United States Patent and Trademark Office

APPLICATION NO.	FILING DATE	FIRST NAMED INVENTOR	ATTORNEY DOCKET NO.	ATTORNEY DOCKET NO. CONFIRMATION NO.	
10/047,101	01/17/2002	Daniel P. Carter	219.40000X00	219.40000X00 5731	
23838	7590 12/16/2003		EXAMINER		
KENYON & KENYON			DUONG, THO V		
1500 K STREET, N.W., SUITE 700 WASHINGTON, DC 20005			ART UNIT	PAPER NUMBER	
			3743		
			DATE MAILED: 12/16/2003	13

DETAILED ACTION

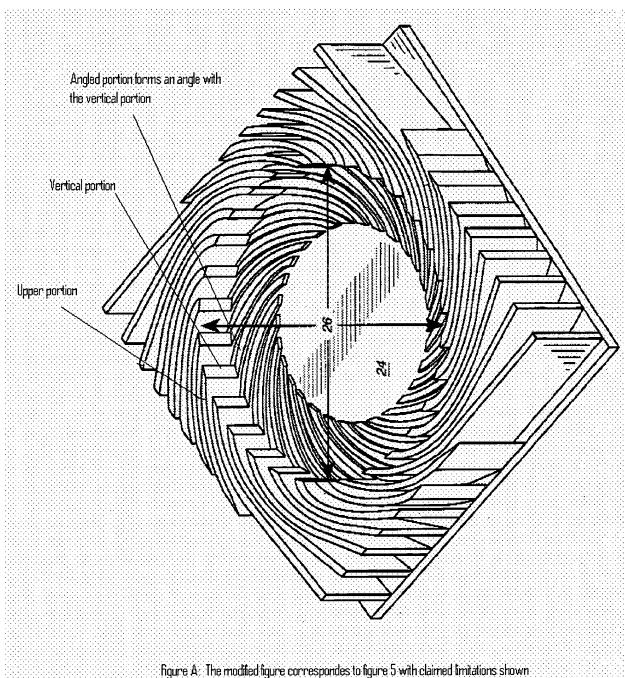
Claims 1-3,36-38 and 40-42 are rejected under 35 U.S.C. 102(b) as being anticipated by Mira (US 5,661,638). Mira discloses (figures 5-6 and column 3, line 56-column 4, line 2) a heat sink comprising a core (24) having a central axis; and a plurality of cooling fins (22) arranged about the core, wherein the fins (22) extending radially away from the core (24) and the fins (22) has been curved (bent) along its height (the curved portion extending from top to bottom edges of fin) to obtain arc-shaped fins (22) in order to capture at least a part of tangential component of airflow. Mira further discloses (figure 6 and figure A as bellow) that each fin (22) has a vertical portion and an angled portion, which also bent in the same direction. It appears in figure A that the vertical portion and the angled portion form a 90 degrees angle.
